EDFV 800 wide with 19" perforation

Num: Eldon_200710_15

Full vented doors 800 wide now with 19" wide perforation

19 Inch wide perforation

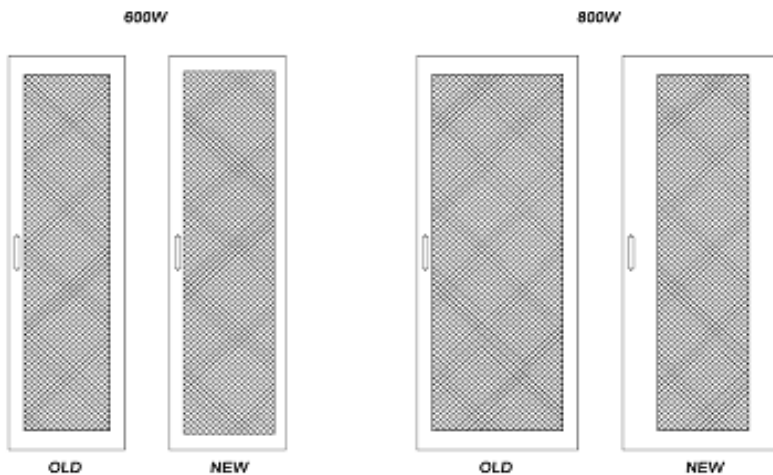
Next to the 600 wide EDFV ventilation doors, which were already equipped with a 19-Inch wide perforation, Eldon will now also change the 800 wide versions. Both widths will be offered with a 19-Inch wide 80, 3% punching for maximum cross-flow, guiding the cold air directly to the servers.

The left and right hand side of the door (next to the punching) now covers the sides next to the 19-Inch profiles in the (server) rack, which gives a much more appealing appearance to the rack. This is because the sides are now covering any patch or power cables, which might be in plain site.

The change will be effective as of the 29th of October 2007.
All 800 wide EDFV doors with the new perforation width will be marked with: "New 19-Inch perforation width"

EDFV. Flush full vented door (80,3%) with swing handle

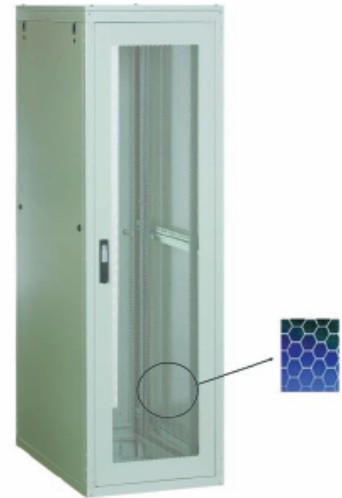
Different situations:
